**From:** Katz - DNR, Aaron <aaron.katz@state.co.us>  
**Sent:** Tuesday, March 15, 2022 5:01 PM  
**To:** Jon McDonald  
**Cc:** Kussum Kanguru  
**Subject:** Re: GV 22-29

**From:** Jon McDonald  
**Sent:** Wednesday, September 22, 2021 10:33 AM  
**To:** Katz - DNR, Aaron <[aaron.katz@state.co.us](mailto:aaron.katz@state.co.us)>  
**Subject:** GV 22-29

AVERAGE LINE PRESSURES BY WELL, SPLIT BY PAD

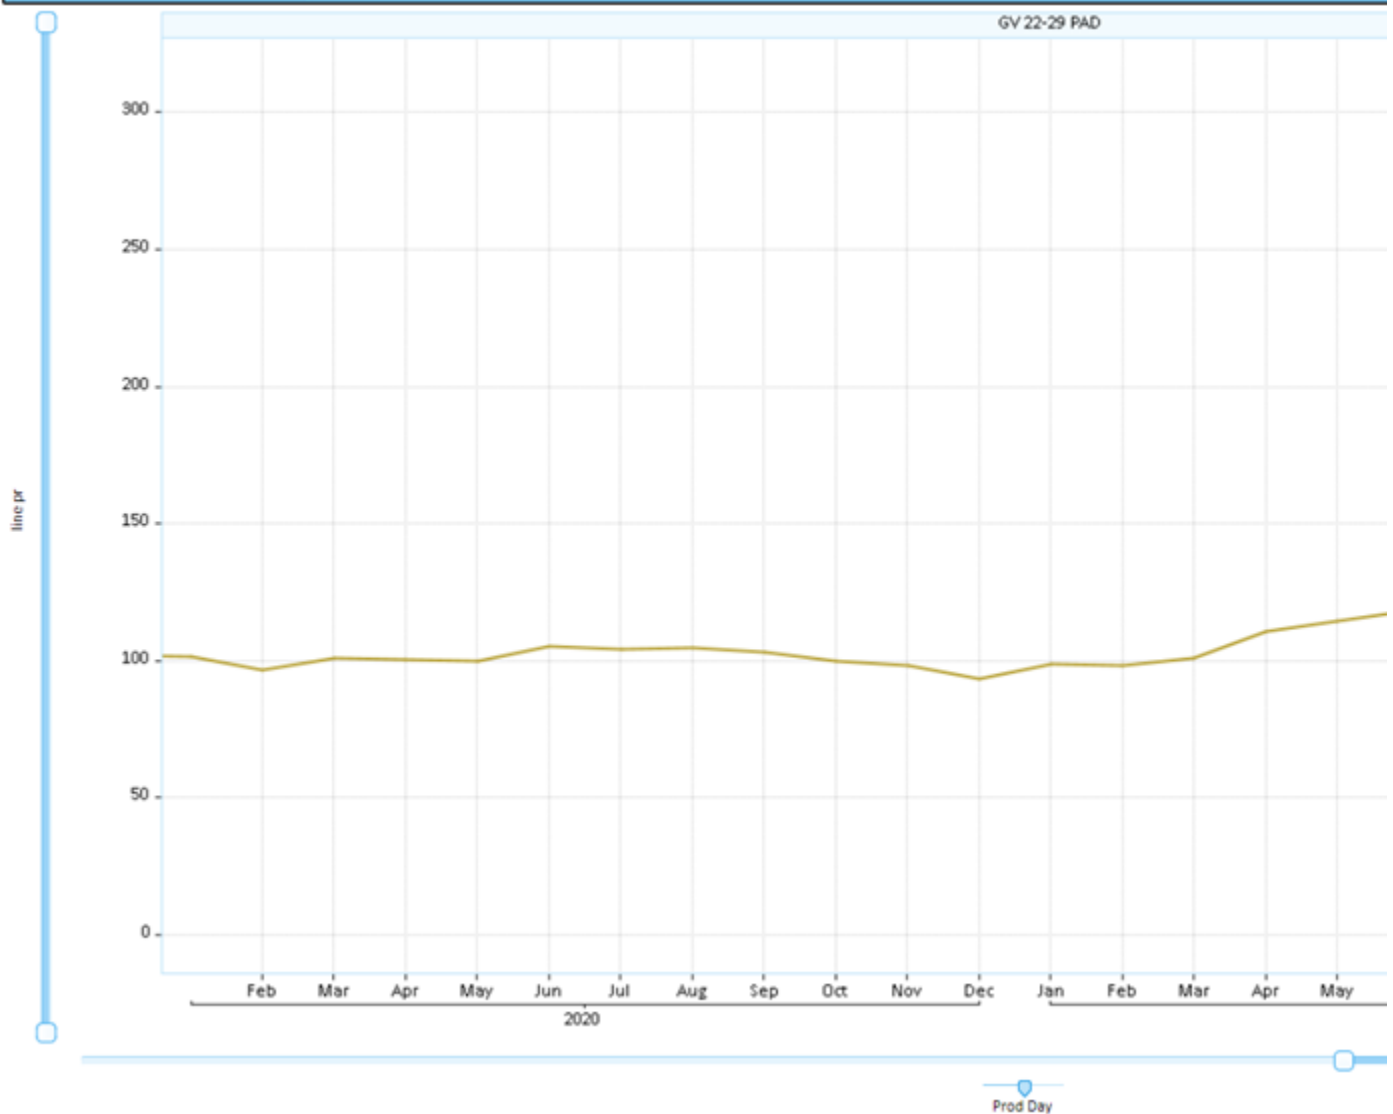
I put the 2 year LP chart for this pad below and the highest its been for the past 2 years is 118#

If we tied this wells bradenhead into LP and requested 120psi as the new BH threshold this would give us the following pressure at the shoe:

118	psi	LP
94	ft	Fluid level
92	psi	hydrostatic
210	psi	equiv pressure at shoe
0.68	psi/ft	equiv gradient

If this is an agreeable plan I will submit the form 4 for tie in and request to increase the BH threshold from 92psi to 120psi.

Jon, Thank you for the update and details on the build rate. Please submit a sundry requesting the 120 psi threshold and plan to tie it into the sales line. Please include the sales line pressure chart with the sundry. Thank you.
